**CITY OF FREDERICKSBURG
HISTORIC REVIEW BOARD
TUESDAY, MAY 11, 2021
5:30 P.M.**

7. CERTIFICATE OF APPROPRIATENESS APPLICATIONS

Application Number: 21-44
Date: May 11, 2021
Address: 207 W San Antonio
Zoning: CBD
Owner: West End Pizza
Applicant: Andy Bray of Mustard Design
Rating: High
Proposed Modifications: installation of railing on porch

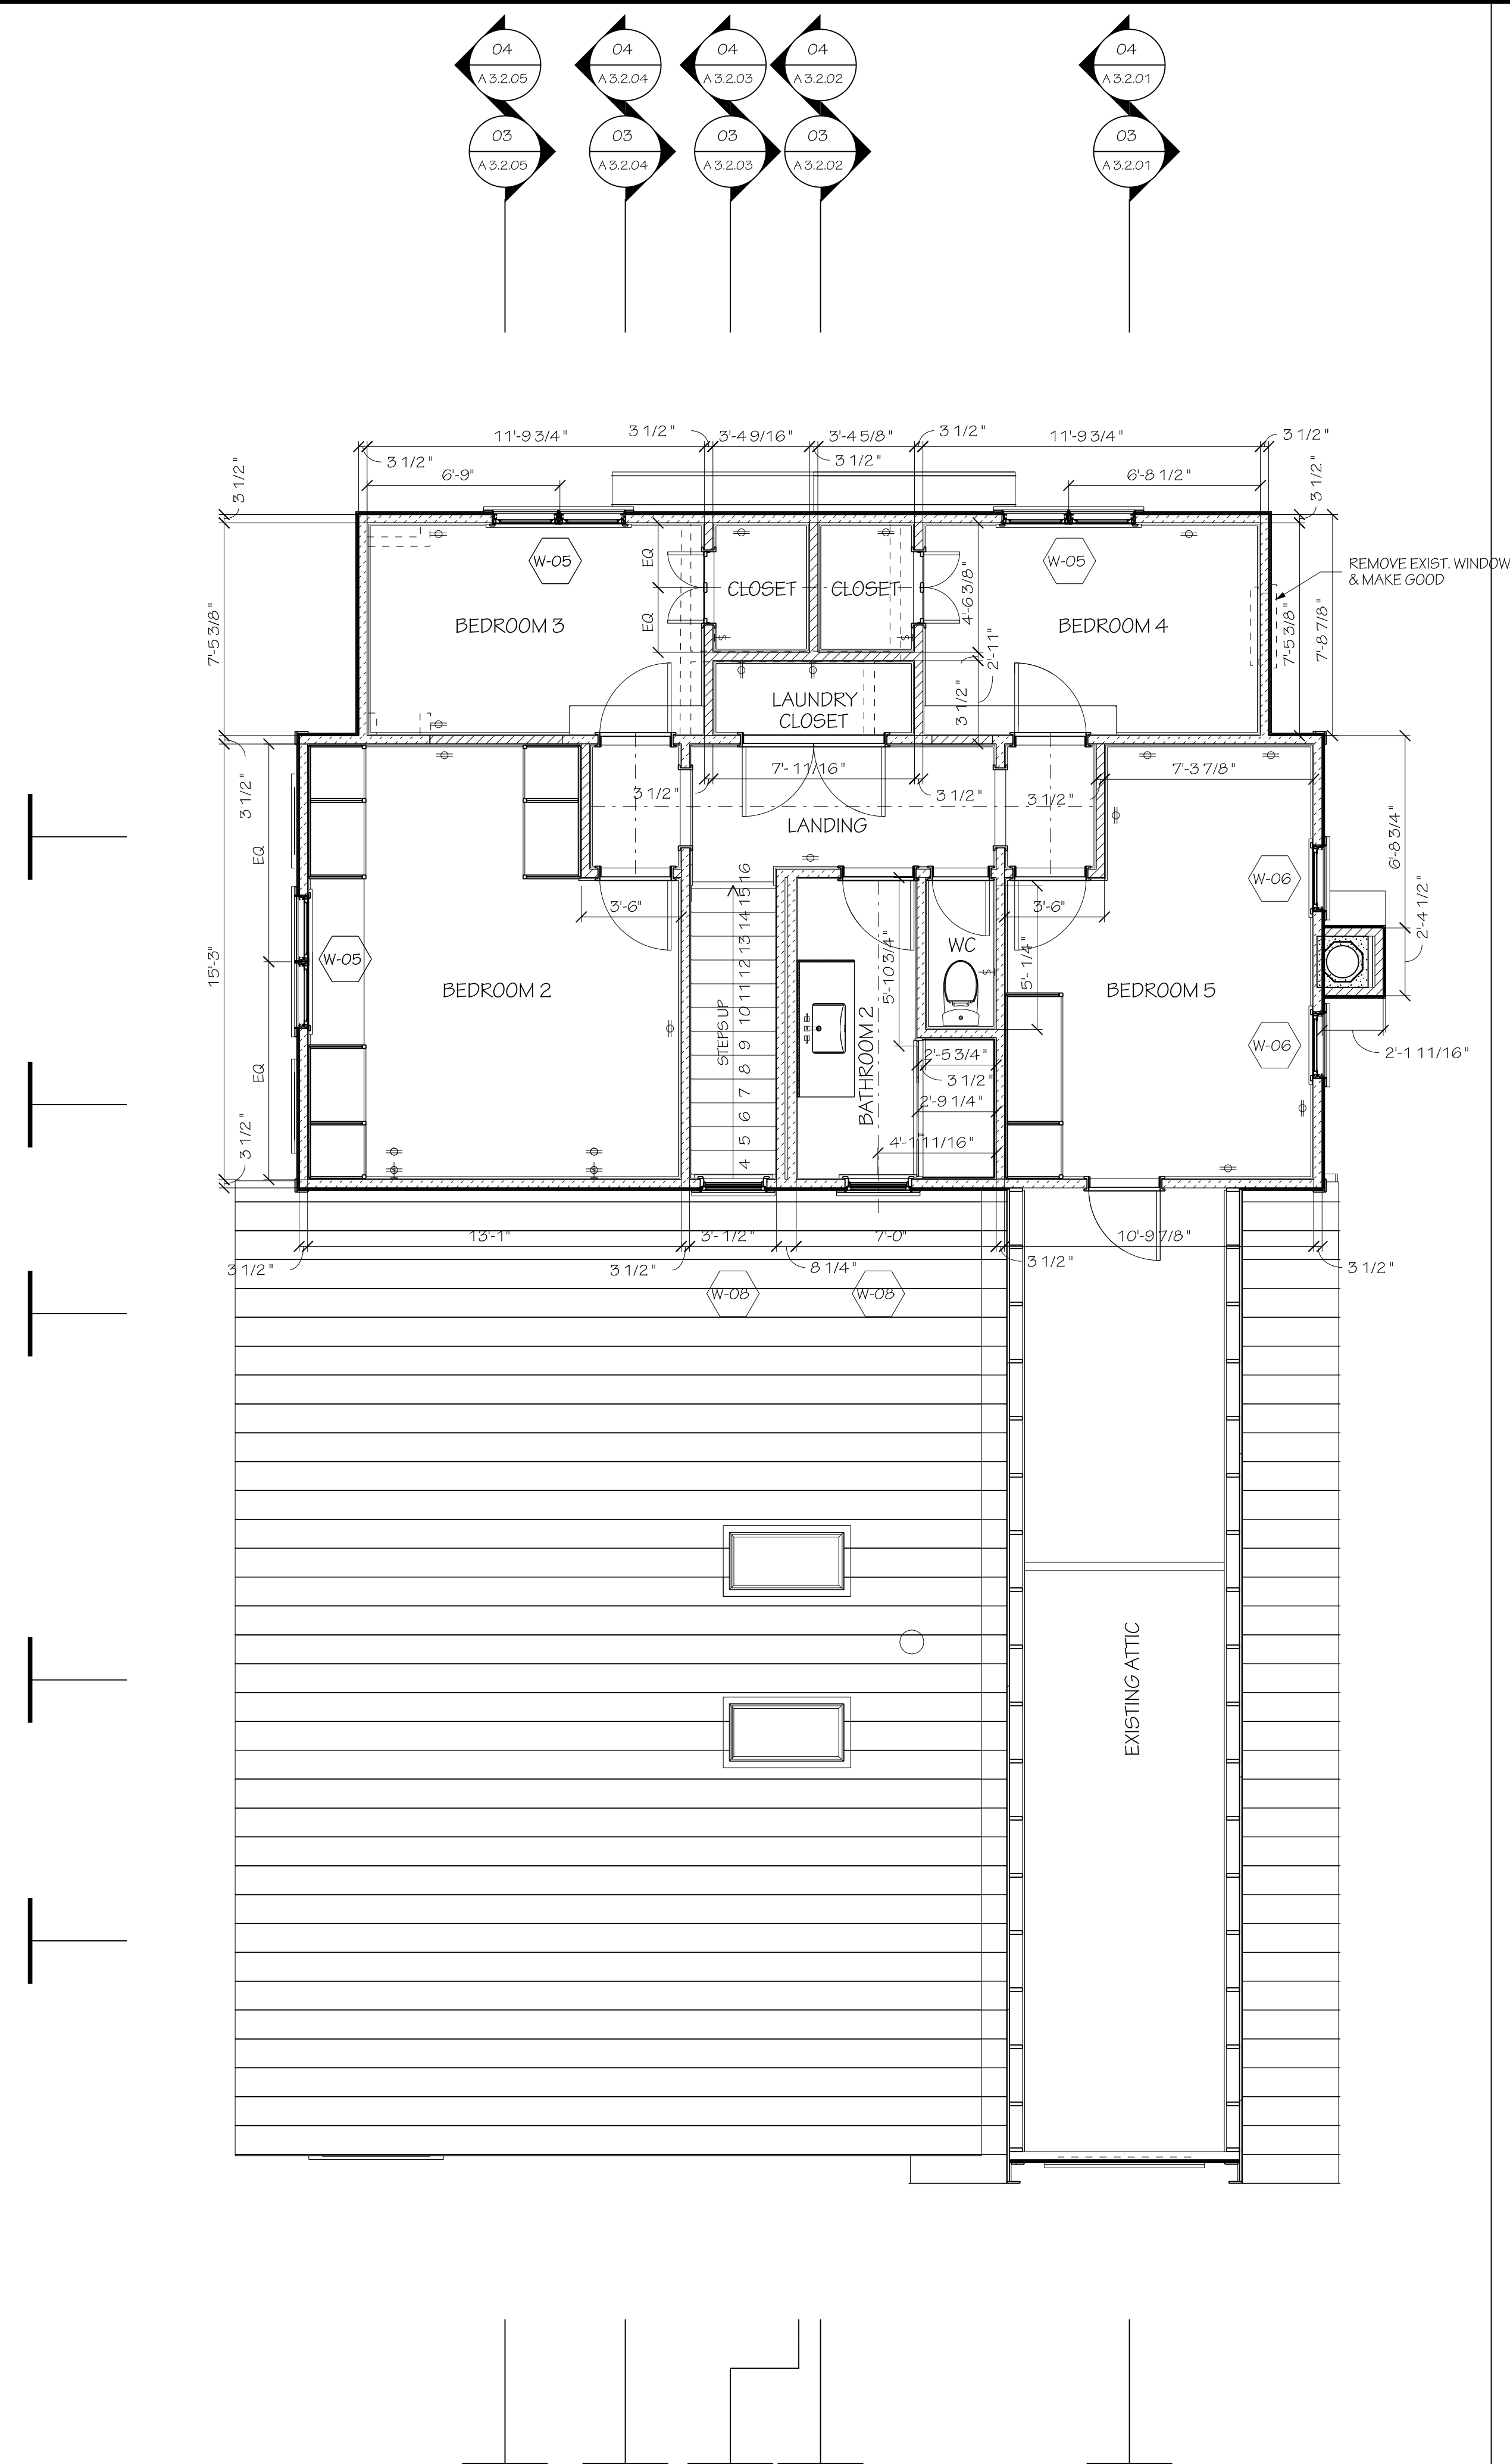
Bay window added in 1950s. In repairable condition.

Shutters not historically accurate, can be removed.

2nd floor windows replaced in 1950s, in poor condition

1st floor 4/4 windows
original windows, in
repairable condition

A. The 1910's vintage house at 610 W San Antonio has a medium rating. The house was significantly altered in the 1950s by the Penick family by removing original Victorian features and enclosing the 2nd floor porch to create living space and adding a bay window the left of the front door. Two rear additions have been added over time. The only original windows are 4/4 windows on the first floor on the right side of the front door and the first-floor east façade. All other windows have been replaced and are in worse condition than the original windows. Staff recommends approval of the replacement of the previously replaced windows and repair of the original windows. There are a few extant screens that can be repaired or replicated. All window frames have screen attachment hooks in place indicating the original windows previously had screens. The shutters are not original, and most are not proportional to the windows. The shutters can be removed. This recommendation is in keeping with the Fredericksburg Design Guidelines for windows and SOI Standards 6.

- D. The enclosed porch side windows were added in the 1950s by the Penick family.
- E. The rear additions are appropriate in size, style, and material. Staff recommends approval as submitted based on SOI 9 and 10 and FBG Design Guidelines for New Additions.
- F. Staff recommends approval of repair of wood features of the porch and siding with in-kind replacement as needed in keeping with SOI #6.
